QUALITY ASSURANCE -- NON-CONFORMANCE REPORT

Report No: NCR-000988

NCR #: ZPMC-0946

Reference Description: QA found an UT indication after ZPMC had tested and accepted the weld at Traveler Rail 20TR2-039

Welding	Concrete	Other	
Welding	Curing	Procedural	Bridge No: 34-0006
Joint fit-up	Coating	Other	Component: Traveler Rail 20TR2-039
Procedural	Procedural	Description: QA found an UT indication

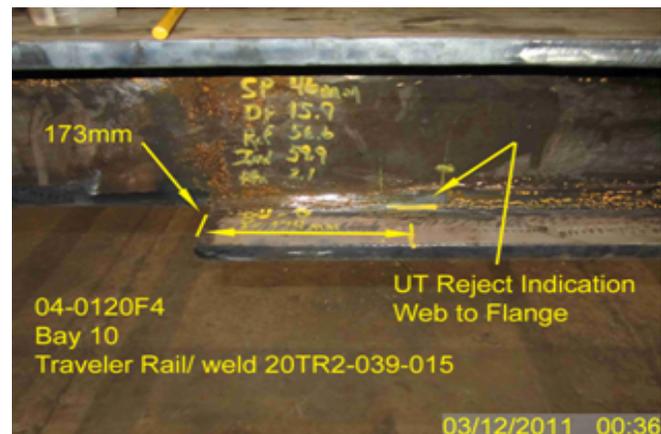
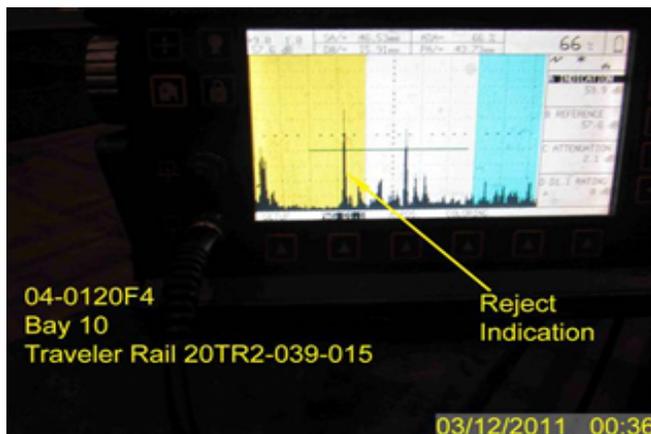
During the Quality Assurance (QA) Ultrasonic Testing (UT) verification of weld located on traveler rail 20TR2-039-015, this QA Inspector discovered the following issue:

- One (1) Class "A" indication measuring approximately 25mm in length.
- The Indication rating is +0dB.
- The thickness of the plate is 20mm and depth of the indication approximately 15.9mm.
- The indication is located on the weld joint identified as 20TR2-039-015.
- The "Y" location for this indication is approximately 173mm from weld termination point.
- The weld is a Complete Joint Penetration (CJP) T-Joint joining web to flange
- The indication is clearly marked by QA on/near the weld.
- Traveler Rail is located inside bay 10.
- The Notice of Witness Inspection Number (NWIT) is 08518. The indication is located within the area that has been previously tested and accepted by ZPMC Quality Control (QC) personnel. As per the contract documents, ZPMC's QC personnel are required to perform 100% UT inspection of this weld.

AWS D1.5-2002, Section 6, Table 6.3. Specifies a class A indication as having a dB rating of +10 and lower for weld thicknesses 8mm through 20mm.

Joint fit-up Coating Other Component: Traveler Rail 20TR2-039

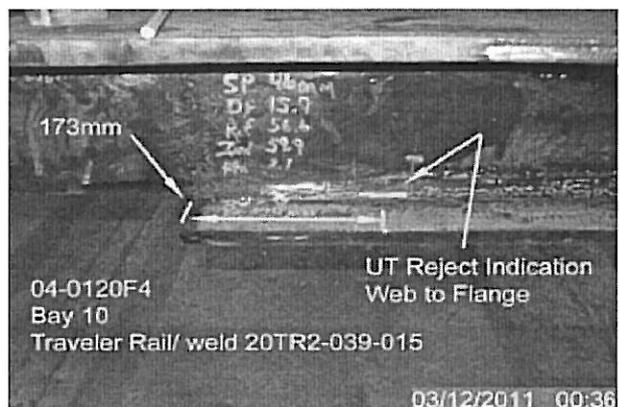
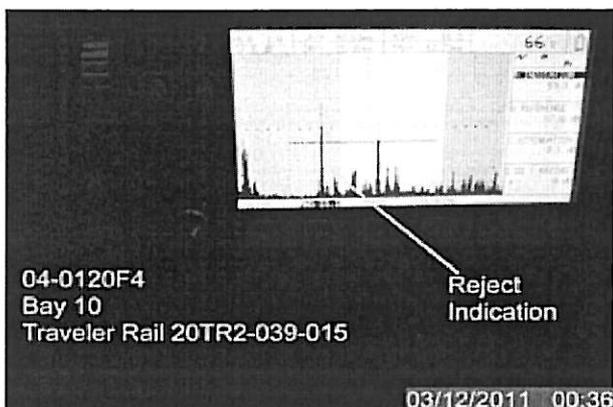
During the Quality Assurance (QA) Ultrasonic Testing (UT) verification of weld located on traveler rail 20TR2-039-015, this QA Inspector discovered the following issue:

- One (1) Class "A" indication measuring approximately 25mm in length.
- The Indication rating is +0dB.
- The thickness of the plate is 20mm and depth of the indication approximately 15.9mm.
- The indication is located on the weld joint identified as 20TR2-039-015.
- The "Y" location for this indication is approximately 173mm from weld termination point.
- The weld is a Complete Joint Penetration (CJP) T-Joint joining web to flange
- The indication is clearly marked by QA on/near the weld.
- Traveler Rail is located inside bay 10.
- The Notice of Witness Inspection Number (NWIT) is 08518. The indication is located within the area that has been previously tested and accepted by ZPMC Quality Control (QC) personnel. As per the contract documents, ZPMC's QC personnel are required to perform 100% UT inspection of this weld.

AWS D1.5-2002, Section 6, Table 6.3. Specifies a class A indication as having a dB rating of +10 and lower for weld thicknesses 8mm through 20mm.

焊缝编号为： 20TR2-030-015,20TR2-039-015

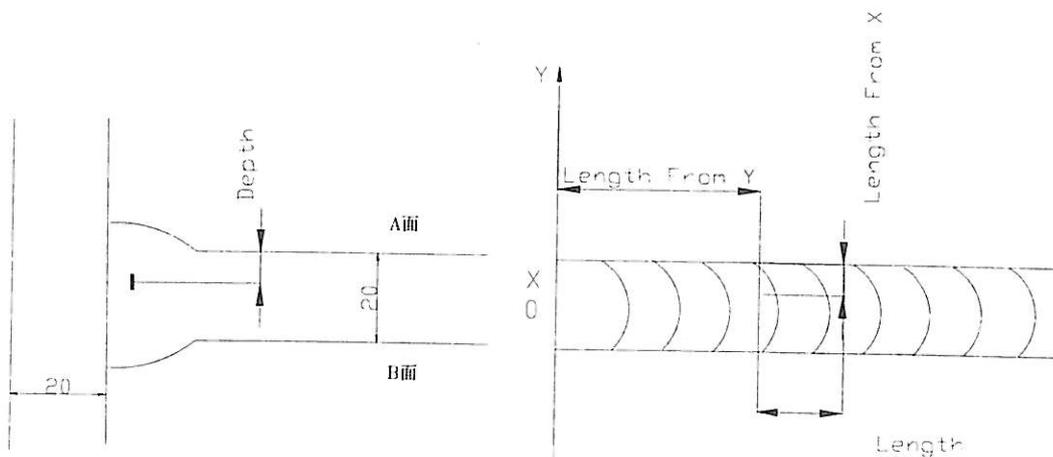
焊缝缺陷描述：(普通UT探伤发现的缺陷长度小于最大允许长度)

(Description of welding discontinuity): Rejected indication found by ultrasonic inspection is less than the maximum allowance aggregate length.

1. Did not clear the weld pass completely in time.

1. Gouge or grind from nearer side from metal edge ($D \leq 0.65T$, "D" is depth of defects, "T" is thickness of metal) to remove all defects;
2. Follow repair WPS for joint preparation, preheat, and weld deposit;
3. Grind the repaired area flush with base metal or the adjacent weld;
4. Check the welds according to the working drawings.
